San Mateo County Board of Supervisors Meeting

Applicant's Appeal

Arborist's Review

**2050 Santa Cruz Avenue
Menlo Park, CA 94025**

A PROPOSED ROADWAY SECTION AT TREE #1

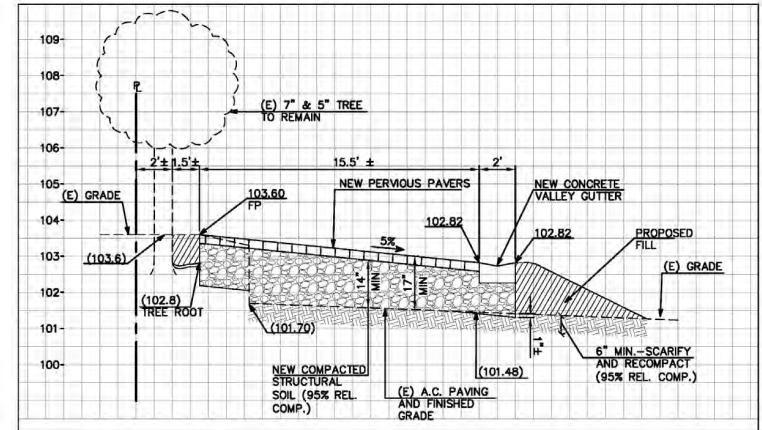
- i. Evaluate the document entitled "Proposed Roadway Section at Tree #1" – as well as similar cross sections to be provided by the applicant on the other two oak trees to be preserved along that left side of the proposed roadway -and provide recommendations regarding the preservation of trees along proposed Cardinal Court during and after construction. Review all cross sections given a reduced roadway width should that reduced width be allowed by Menlo Park Fire Protection District. In the event

Image 1:
Cardinal Pass
Road Section
for Tree #1

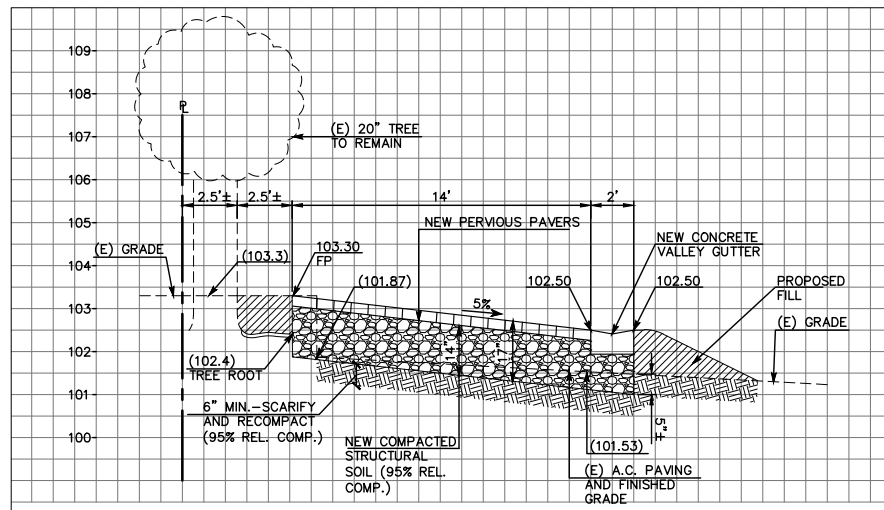
The plans indicate the proposed Cardinal Pass Road will be constructed within one foot of trees #1, #2, and #26. It was determined during the site visit on February 2, 2017 that tree #3 was not suitable for transplanting and #4 was already designated for removal. The “Proposed Road Way Sections” indicate the grade raised and sloping upward to meet the existing grade of the trees (Image 1). This section shows the existing fill within one foot of the trees to be removed and the entire roadway designed with Structural Soil® and pervious pavers. The existing conditions include an asphalt driveway about 5 to 6 feet from the trunks. There is a small rock wall about 12 inches high running parallel to the driveway about 5 feet from the trees. The soil slopes upward to the trunks at least two feet above from the existing driveway.

The joint trench for the gas and electric utility has been moved into the roadway and around tree #1, and now past #2 and #26 at least ten feet away.

Image 2 (above): Roots emanating from the blue oak #1.

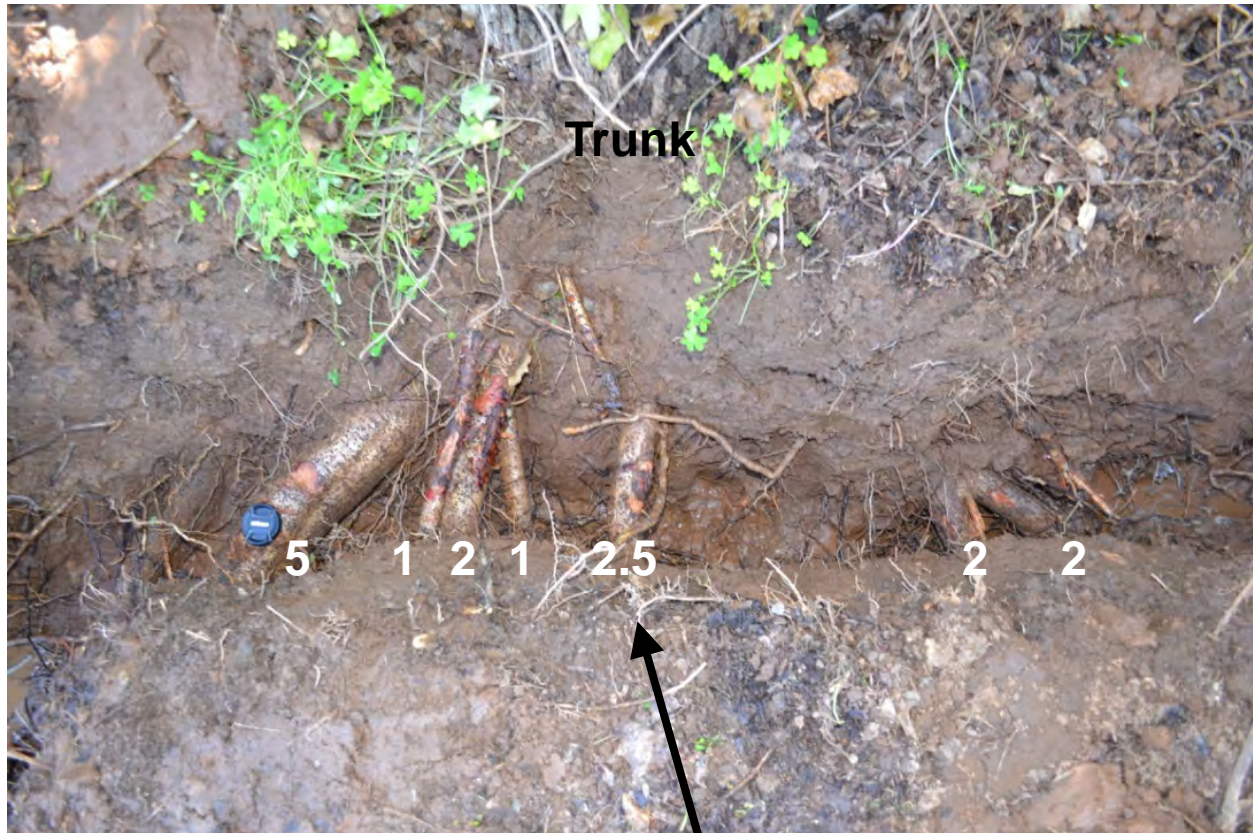
Blue oak #1: Roots revealed in diameter inches left to right: 5, 1, 2, 1, 2.5, 2, 2 at a depth of 16 inches (Images 2 and 3)

Image 11: Roadway Section with existing root location and ultimate height/depth of Cardinal Pass Way.

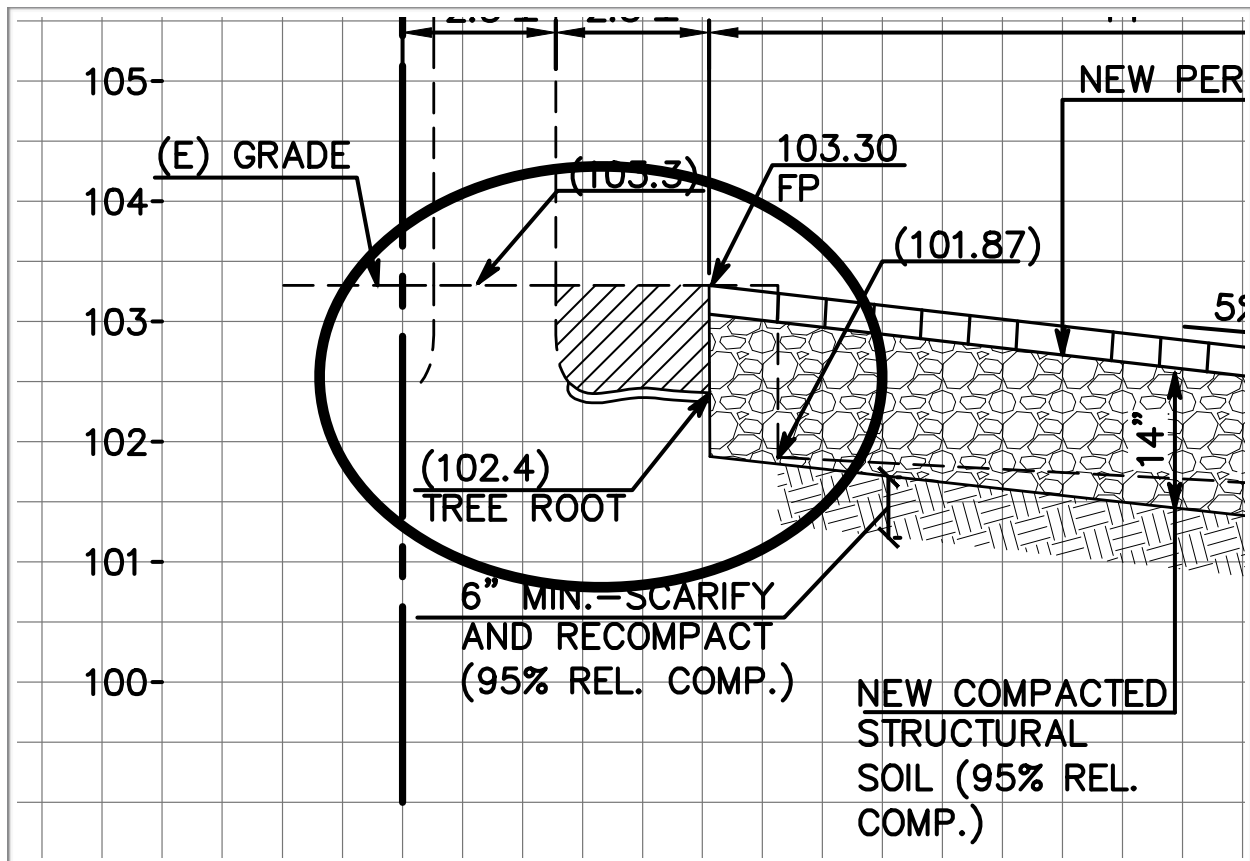
The section of road engineering provided indicates the existing soil up to the trunks is to be removed and then filled back with Structural Soil® (Note: Structural Soil® is a trademark of Cornell University and is also commonly referred to as “engineered soil mix” to avoid trademark issues). This could be accomplished if the soil is to be removed through Hydrovac® or Air Spade® excavation. This type of soil replacement could preserve roots in place provided critical roots are avoided. Backfilling the entire area over the roots could be accomplished in theory, but could prove difficult in reality. There may also be other materials or techniques to allow for air exchange at the root/road interface which should be explored.

Root removal or cutting will significantly compromise the trees #1, #2, #26, and #27 and a soil replacement regime could allow for tree preservation and the construction of the roadway with varying results. The trees could survive this process or they could perish within a few years. Nevertheless there would be infrastructure in place to plant new trees with success in the event the trees decline or die.

There is another concern with the roadway section of the plan that could be a result of poor guidance and no fault to the engineer. The sections for each tree indicate the new grade of Cardinal Pass Way with all the Structural Soil® and pavers will match the existing grade. However, this may not be necessary because the trees were somewhat buried in fill with roots about one foot below grade to start with. For example the new finished grade is approximately one foot higher than the depth of the significant roots identified in most instances. There may not be a need to raise the roadway surface this high over the existing roots unless it is for structural or road stability purposes (Image 11). Another alternative is to just use pavers and Structural Soil® under the trees, or within a designated area, and construct the remaining portion of the roadway with other materials. This would allow for a “Tree Well” under the trees that could support both existing or new plantings if required.
